NOTICE OF ADDENDUM: ADDENDUM 1

CONTRACT NO. 7895 HUGHES PLACE STORM RELIEF AND RESURFACING - 2017

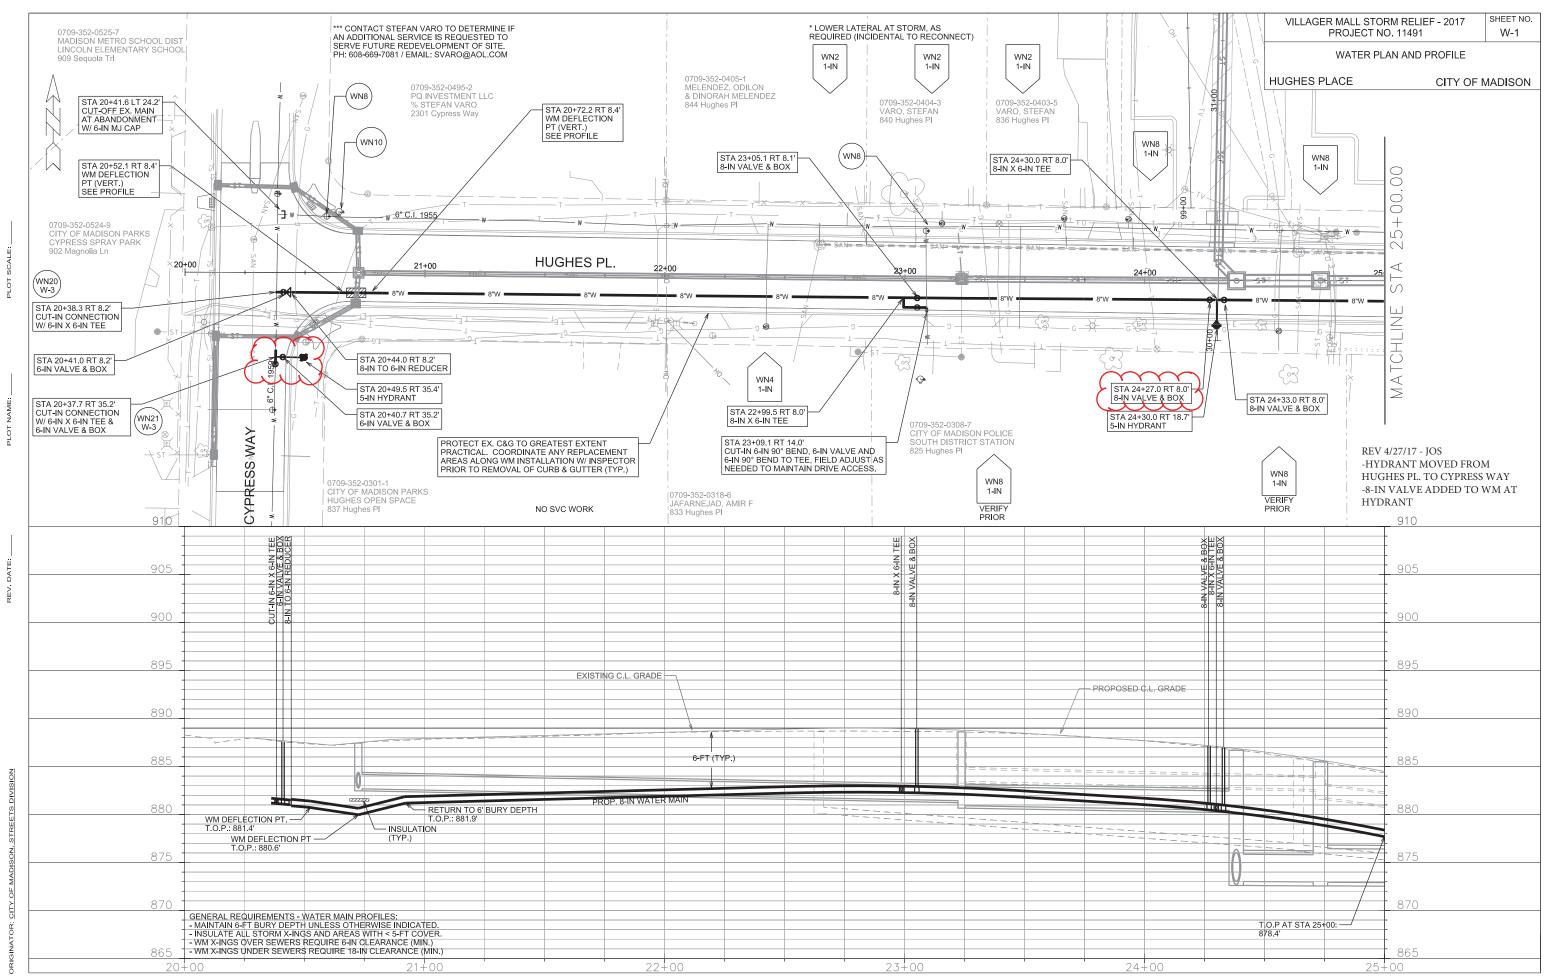
- Insert Sheets W-1 to W-4 (revised 4-28-17)
 - o W-1: Relocate hydrant at Cypress Way and revise valves at STA 24+27.
 - o W-2: Reprint to depict correct storm sewer design.
 - o W-3: Revised to reflect design changes shown on sheet W-1.
 - o W-4: Revised to reflect design changes shown on sheet W-1.

W-4

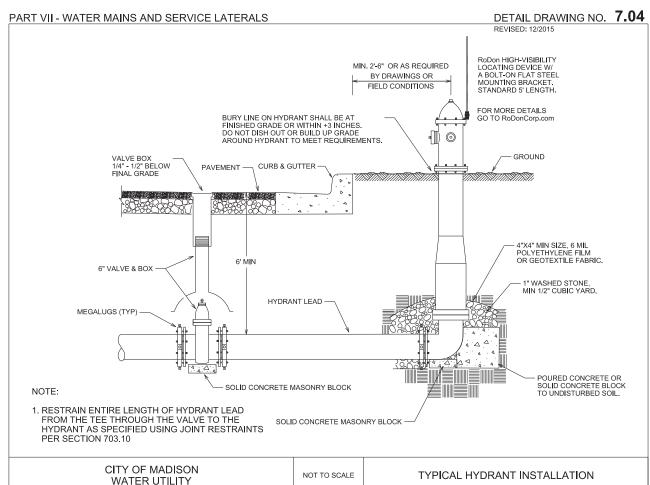
REV 4-28-17 JOS REFLECTS 4.28 REVISIONS
